CITY OF DALLAS

RE: Appeal of Certificate of Appropriateness:
Hearing – October 3, 2022
4512-4518 Sycamore St., Case No. CA212-354(RD)

**4512-4518 SYCAMORE
STREET
APPEAL
CA212-354(RD)**

**City Plan Commission
Hearing
01/05/2023**

Photo #1 (duplex #1)

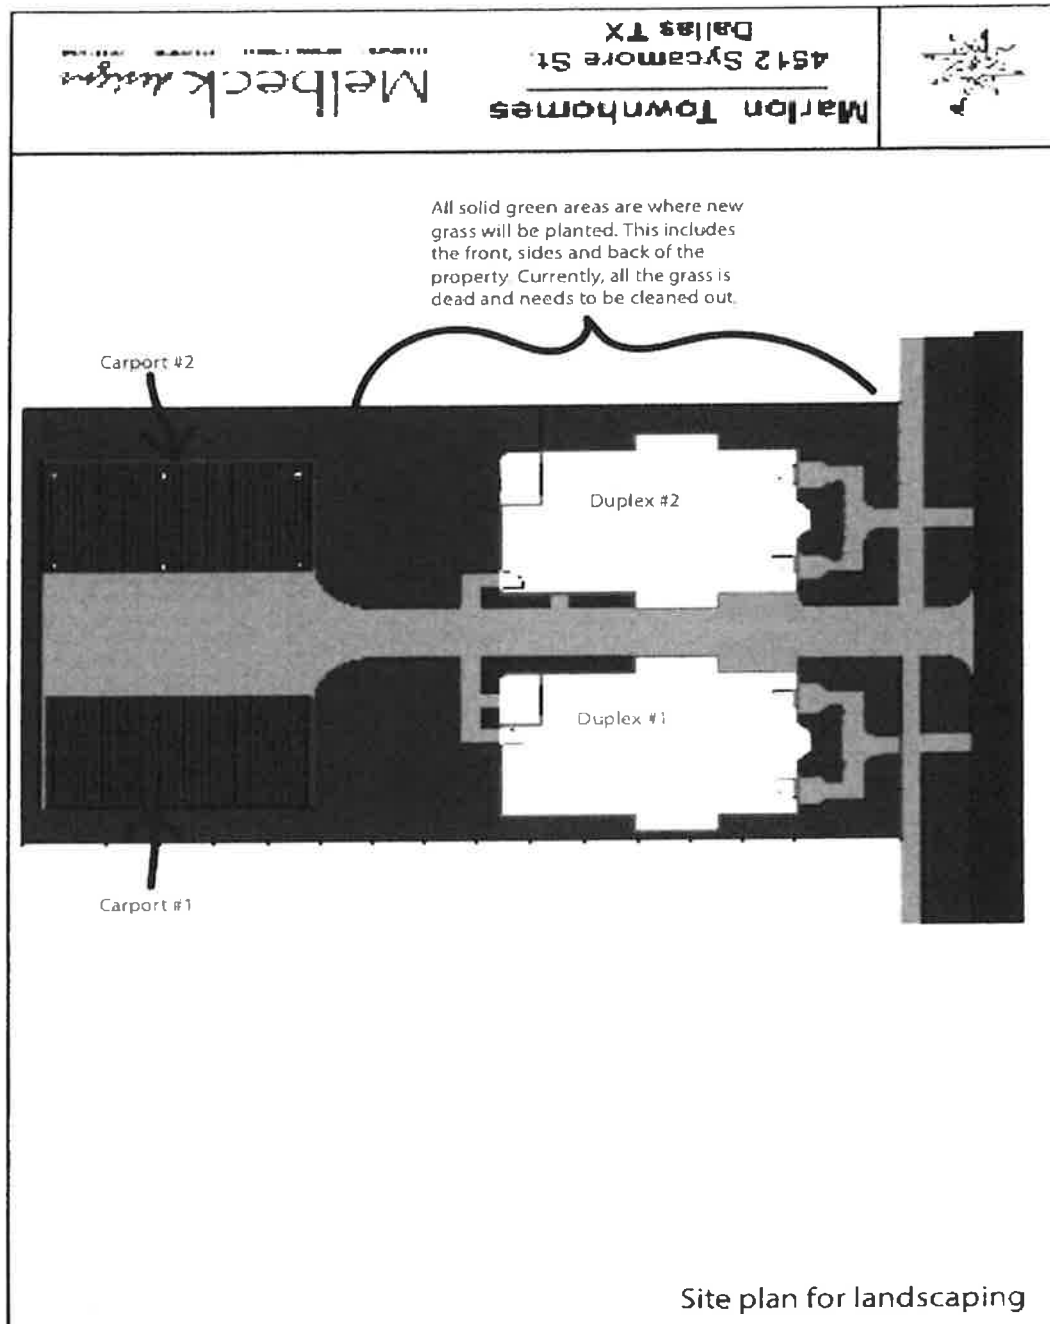
The applicant proposes to replace a chain link fence, around rear and side yards with an eight-foot high, (pine) wood picket fence. According to the applicant, the prior fence was in disrepair and vagrants were entering the property through holes in the fencing. The newly installed fence is a privacy fence; however, the side elevations of both buildings are visible from the public right-of-way.

2. That the request for a Certificate of Appropriateness to replace chain link fence around rear and side yards with wood fence be **approved** as submitted.

SASH - EXPLODED VIEW

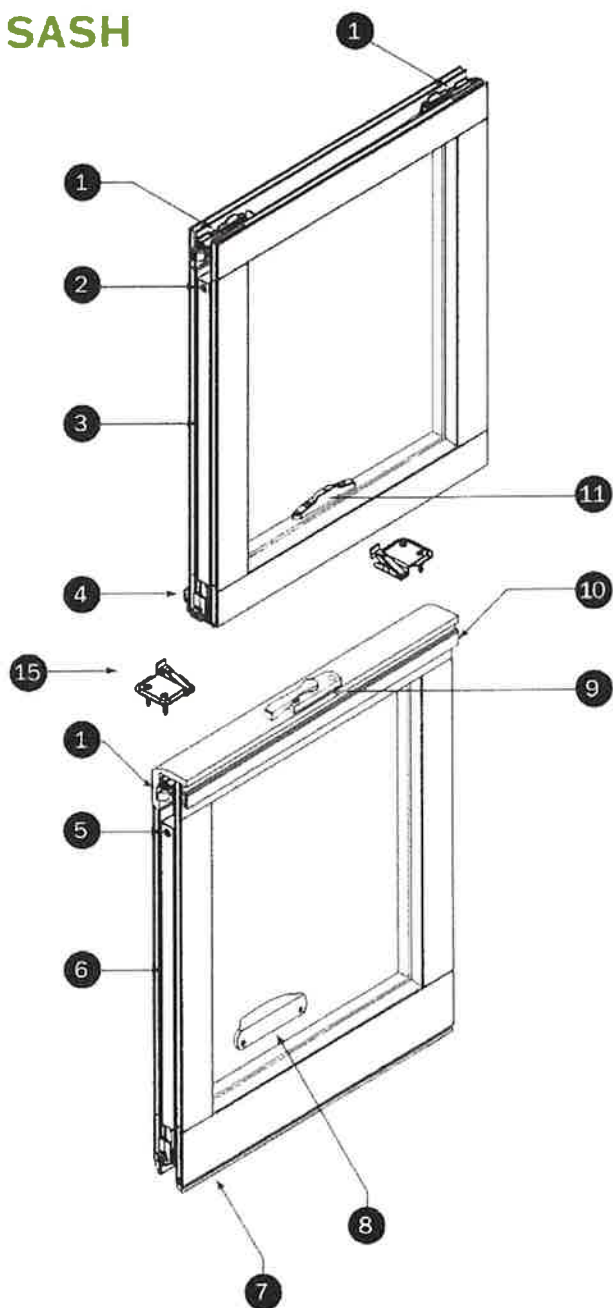
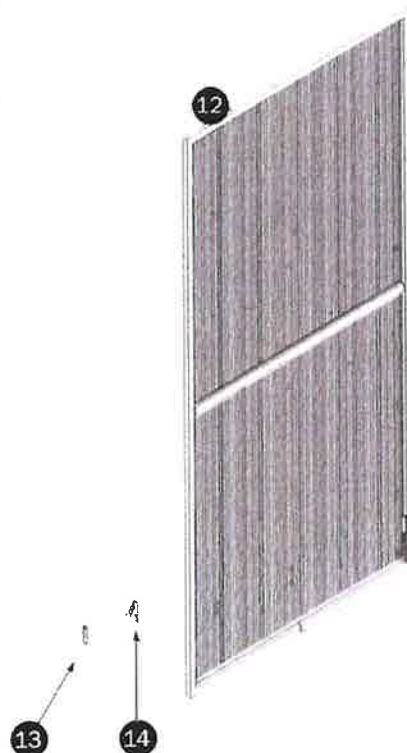
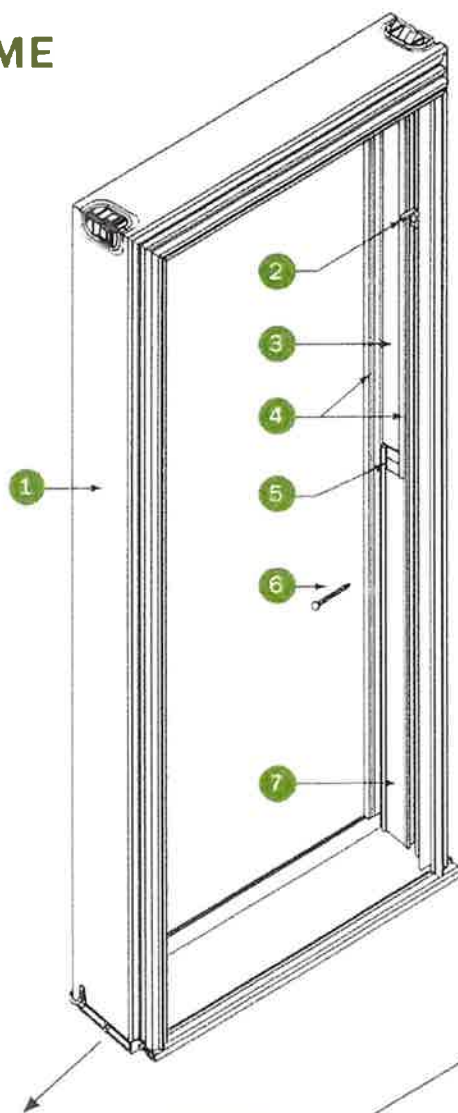
11 COMMISSIONER ANDERSON: Second
12 question is the wood composite windows.
13 This historic district requires wood
14 windows. We do not allow things such as
15 Hardie Board because it's an imitation
16 material. So I'd like to get more
17 information on what wood composite
18 windows are and how they are to be used
19 in this historic district.

2 don't see on the detail that's provided
3 that -- it looks like the meeting sash
4 is the same dimension as the side rail
5 sashes and the top rail sashes. I don't
6 see a difference between your meeting
7 rail sash. That's a very prominent
8 feature on historical windows, interior
9 windows, and I don't see that.

14 COMMISSIONER CUMMINGS: No, I'm
15 talking about the bottom sash. There's
16 also indications of differences on the
17 thickness of the meeting sash, but let's
18 just talk about the bottom sash. What's
19 your dimension on your bottom sash? And
20 I also don't see a sill detail that was
21 called out, and you had three choices on
22 the windowsills.

11 COMMISSIONER CUMMINGS: Correct.
12 It doesn't seem like there's a
13 difference between the bottom sash
14 dimension and the side dimension.

5. That the request for a Certificate of Appropriateness to replace wood windows with wood composite windows be **denied**. Wood composition windows are not wood, and these windows would have an adverse effect on the historic district. Work is not consistent with 51A-4.501(g)(6)(c)(ii) for non-contributing structures. Proposed work is not compatible with the historic district.
